Service Bulletin

ct:	AIR TEMPERATURE WILL NOT CHANGE	Bulletin No:	07-003/15
		Last Issued:	02/04/2015

2014-15 Mazda3 (with manual A/C)

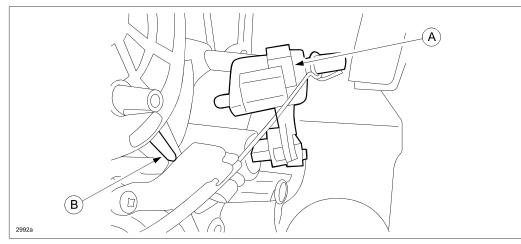
Some customers may complain about that air temperature from the air conditioner will not change by the air temperature control knob, and may be accompanied by some rattle noise from inside of the dash board. This concern may be caused by the temperature control link being pulled out of the HVAC housing. To correct the problem, the temperature control link has been modified.

- 1. Verify customer concern.
- Refer to the instructions on MS3 online or the Workshop Manual (section 07-40 CLIMATE CONTROL UNIT REMOVAL/INSTALLATION [MANUAL AIR CONDITIONER) and check that the MIX LINK (Air mix link/Temperature control link) (A) is properly connected to the MIX DOOR CRANK (B) and works while rotating the temperature control knob.

- a. If it works, this Service Bulletin does not apply. Refer to the instructions on MS3 online or Workshop Manual for troubleshooting and repair.
- b. If the MIX LINK is detached, proceed to the next step.

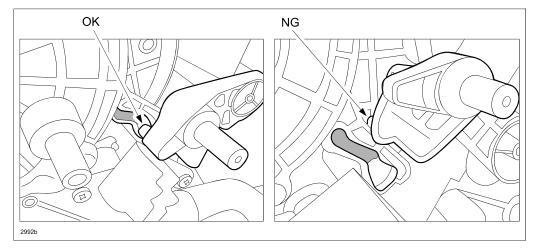
Replace the MIX LINK with a modified one. Refer to MS3 online or the Workshop Manual (section 07-11 A/ C UNIT DISASSEMBLY/ASSEMBLY). Make sure that the MIX LINK is fitted in the groove of the MIX DOOR CRANK and will not come out with movement.

- 4. Install the parts in the reverse order.
- 5. Verify repair.
